Addendum

Reconstruction at
Mahopac High School
Mahopac Middle School
Mahopac Falls School
Bus Garage
New Pump House

BID Addendum No. 3 to Drawings and Project Manual

February 22, 2021

Electrical Site Plan - Site Lighting
and Scoreboard

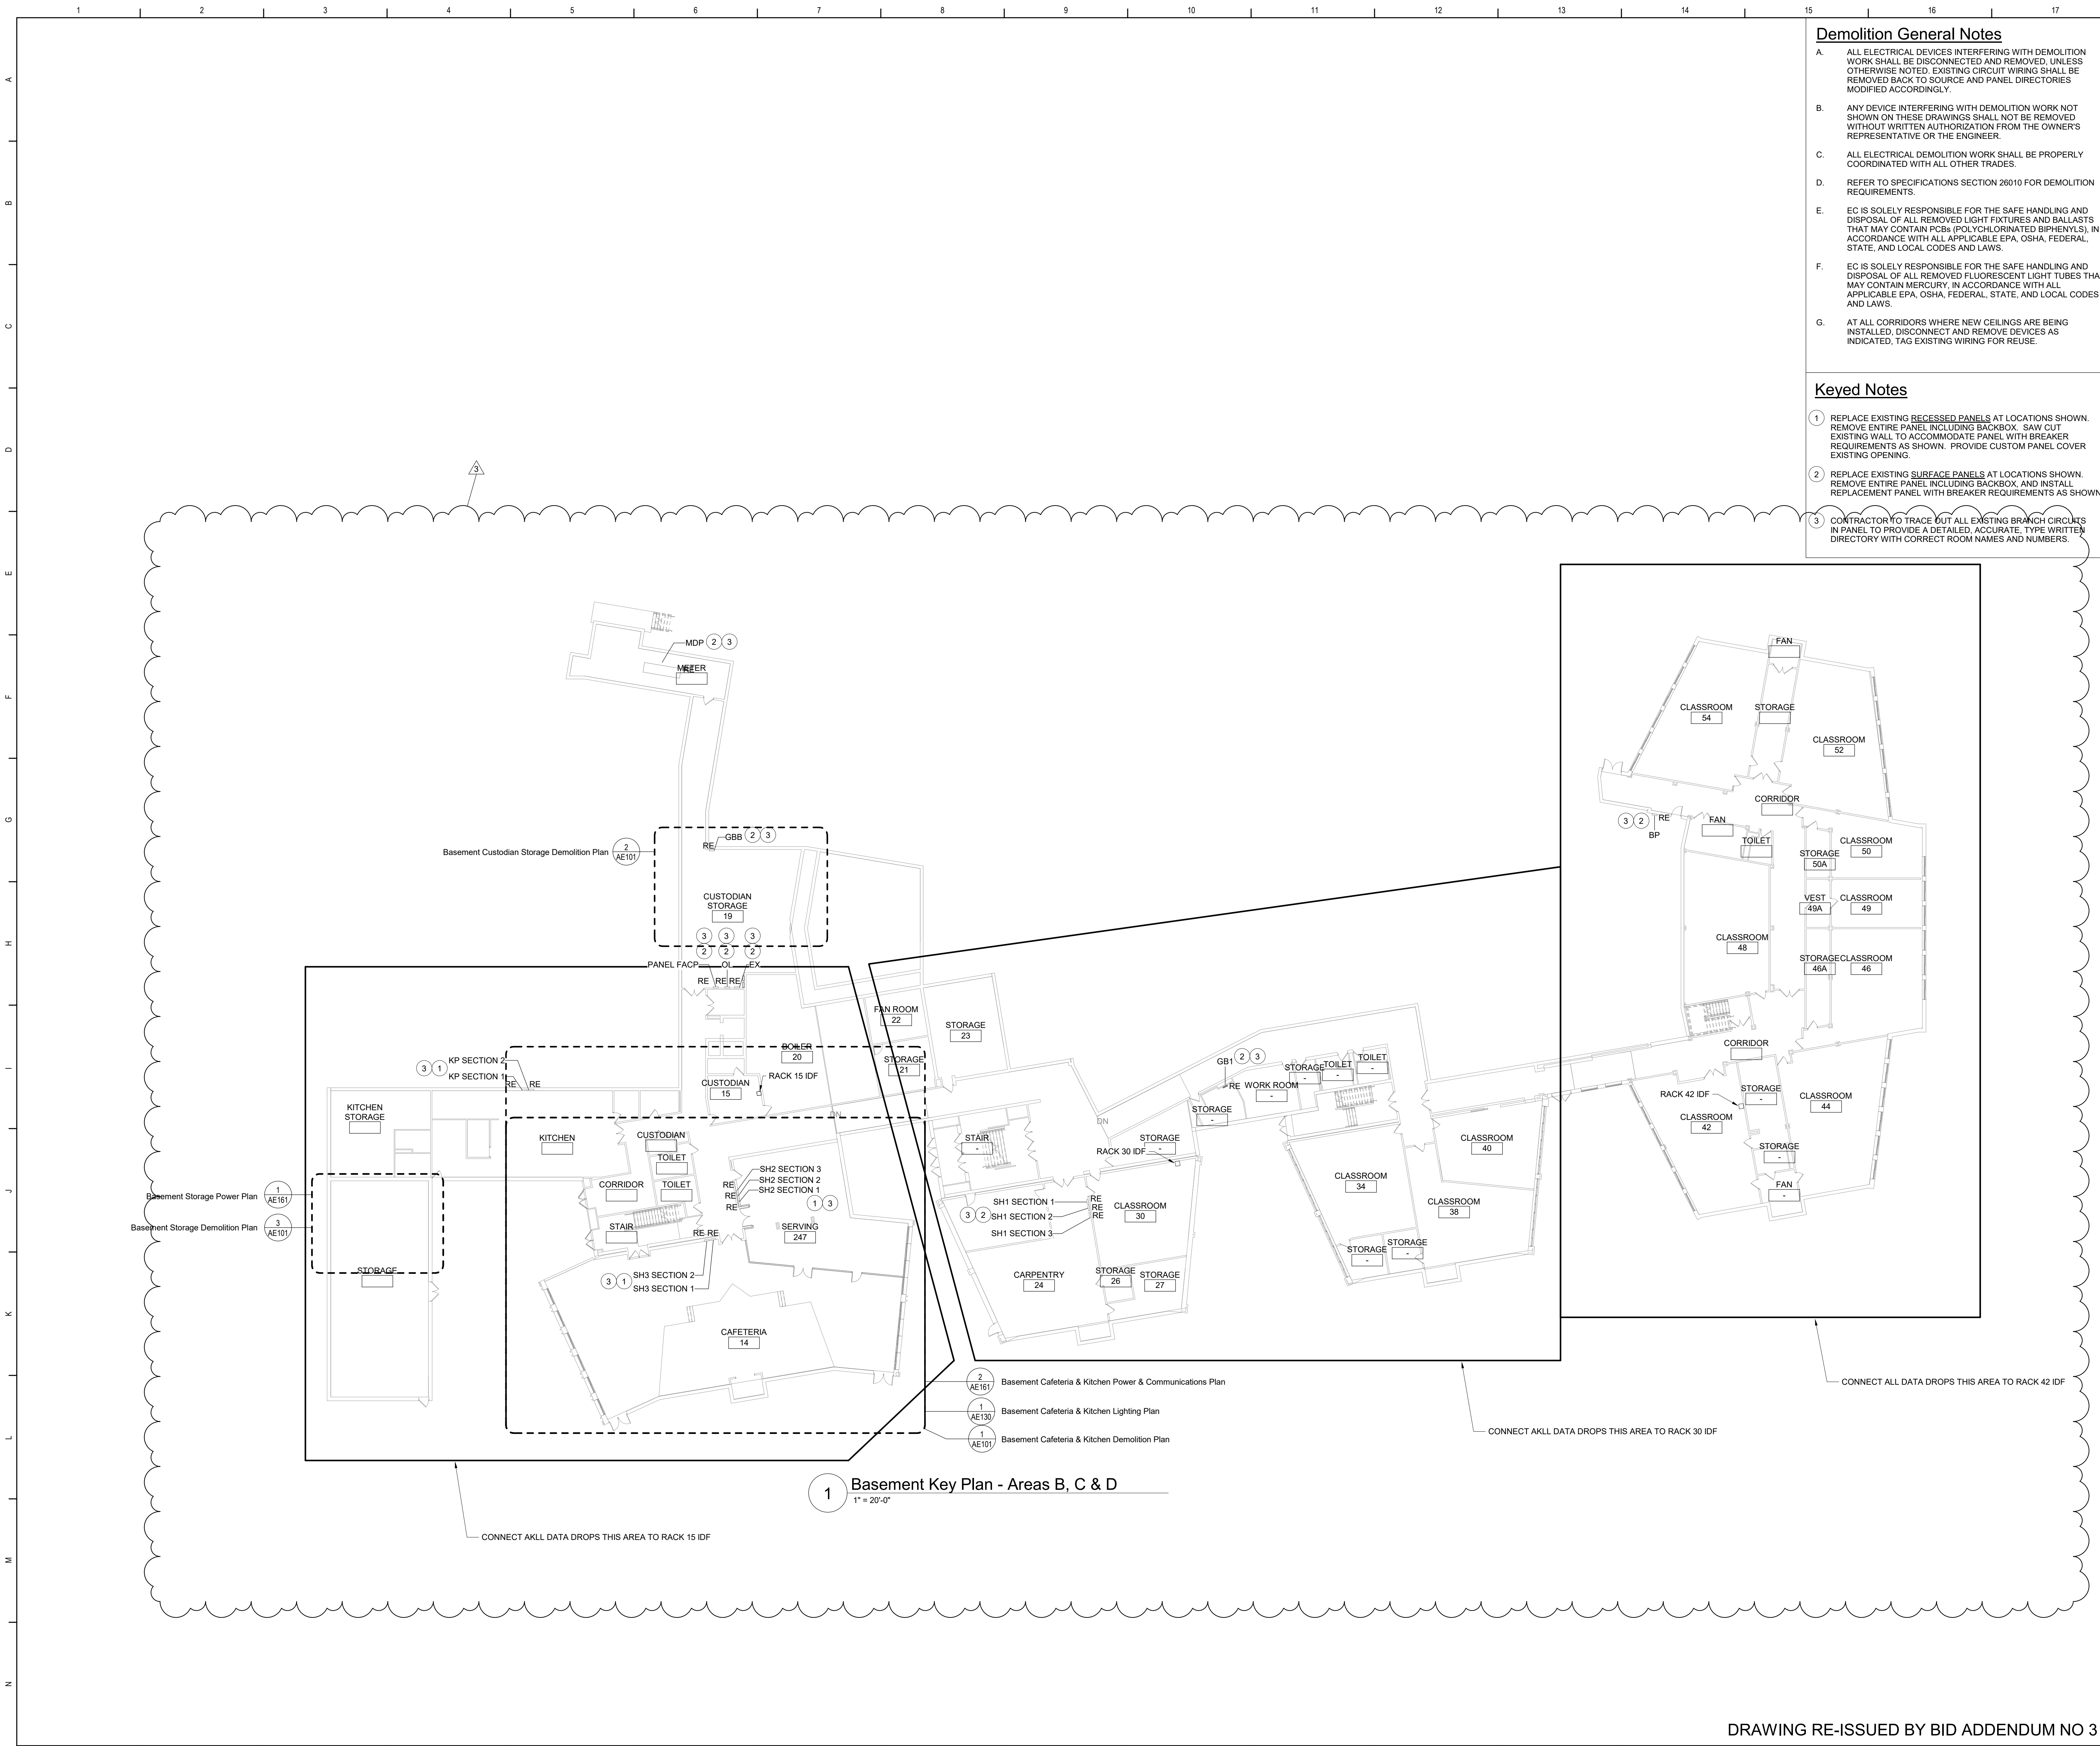
Question: (Please be specific) 1. can you confirm that the GC is responsible for the footings/support of the scoreboard we will furnish and install? Please clarify which trade is doing what scope for the scoreboard?

Question: (Please be specific) 1. HE100 shows panel schedule with circuit feeding scoreboard, and receptacle at scoreboard. Plan AE002 note 3 states for us to extend existing conduit to pumphouse (what size conduit)? Please clarify this scope. I assume no work needs to be done to exiting conduit shown on A001 and that the scoreboard and outlet per notes 1 & 5 on AE002 will be powered by a new conduit and feeder coming from the pumphouse, please clarify/confirm scope?

Question: (Please be specific) 1. note 6 can you confirm the feeder size, drawing is corrupted and does not show the feeder size. Also confirm that the panel in the concession stand is existing and adequate for new load? Also confirm you want an additional spare 2" conduit from concession stand to the field location shown on plan? _

Question: (Please be specific) 1. detail 4/AE002 shows a nema 3R 30A fused disconnect to feed scoreboard, but circuit on panel schedule PH1 in pumphouse shows this as a 20A single pole circuit, please confirm size of disconnect and feeder size for this circuit?
2. note 4 on AE002 does not appear on the plans, is there any scope here we need to include?

The Electrical contractor is to provide a turnkey installation for the scoreboard as shown on AE002. This includes foundations and structure.

REFER TO ADDENDUM NO 3. FEEDER SIZE IS #6 in 1"C
YES PROVIDE SPARE CONDUIT AS SHOWN ON DRAWINGS

1. SIZE SHOWN IS CORRECT
2. REFER TO ADDENDUM NO 3
